Subject: City of Vancouver Comments on the Draft EIS for I-5 Columbia River Crossing

City of Vancouver Comments on Columbia River Crossing DRAFT EIS						
CHAPTER	PAGE	SECTION	LINE	COMMENT			
SUMMARY							
	S-14	Alternative 4	Figure: Supplemental Crossing with BRT	Shows primary bike/ped pathway on only one side. There is a pathway on the other side too and PBAC recommended widening both sides if this option is chosen.			
	S-16	Alternative 5	Figure: Supplemental Crossing with LRT	Shows primary bike/ped pathway on only one side. There is a pathway on the other side too and PBAC recommended widening both sides if this option is chosen.			
	S-19	Multimodal River Crossing & Highway Improvements	Exhibit 16	Should show bike/ped pathway on Southbound downstream side of bridge not northbound structure.			
	S-21	Multimodal River Crossing & Highway Improvements	Exhibit 18	Shows primary bike/ped pathway on only one side. There is a pathway on the other side too and PBAC recommended widening both sides if this option is chosen.

Figure III-4: Project 3, Discovery Loop / Central City

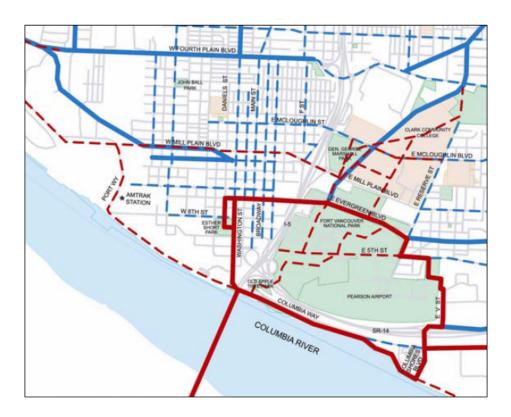
3-201 and following	3.7.2	Long-Term Effects	Does not include the Discovery Trail loop that crosses the APE on Evergreen Blvd. as well as along the Columbia. (See attached section of the 2004 VCPRD Paths & Trails Master Plan describing the trail and planned improvements. In addition, see information on the VCPRD website: <a href="http://www.cityofvancouver.us/parks-recreation/parks">http://www.cityofvancouver.us/parks-recreation/parks</a> trails/trails/discovery loop.htm.)
	3-207	3.7.3	Long-Term Effects	This section should include analysis of the barrier effect of a wider freeway with more cars on it and high sound walls (10 to 18 feet) on the trail connections over it (Discovery Trail and the Seventh Street pedestrian bridge).
	3-207	3.7.3	Long-Term Effects, 1 <sup>st</sup> full paragraph	The Seventh Street pedestrian connection is very important to the urban trails network, and is included in planned pedestrian improvements in the Vancouver Comprehensive Plan. This connection should be included in the project and any alternative that precludes its development is inconsistent with City plans.
